# National Building Code of Canada 2005

## Revisions and Errata

### Issued by the Canadian Commission on Building and Fire Codes

**Figure A-9.3.2.9.(1)-B**  
**Clearances under structural wood elements and visibility of supporting elements where required to permit inspection for termite infestation** ◊

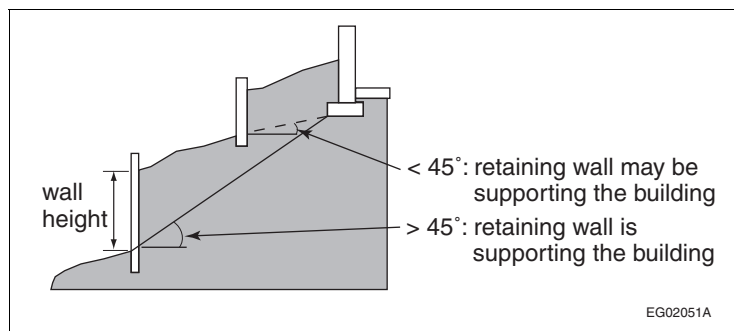
Provision	Erratum	Date of Issue
A-6.2.4.1.(2)(c)	"Carbon Monoxide Alarms" was added as the title of the Appendix Note	07-12-01
Figure A-9.3.2.9.(1)-B	<p>This Figure was replaced with the following one:</p>  <p>clear height of 450 mm between structural wood elements and finished ground directly below</p> <p>supporting elements visible to permit inspection (for height of structural wood elements not directly above finished ground, see Article 9.23.2.3.)</p> <p align="right">EG02050B</p>	07-12-01
Appendix C, Table C-2	Entry for Yukon, Whitehorse under column heading Seismic Data: value of $S_a(1.0)$ was changed to 0.10	07-12-01
<b>Division C, Volume 1</b>		
2.2.4.6.(1)(b)	The terms "allowable bearing pressures" and "allowable loads" were changed to "factored bearing pressures" and "factored loads" respectively	07-12-01
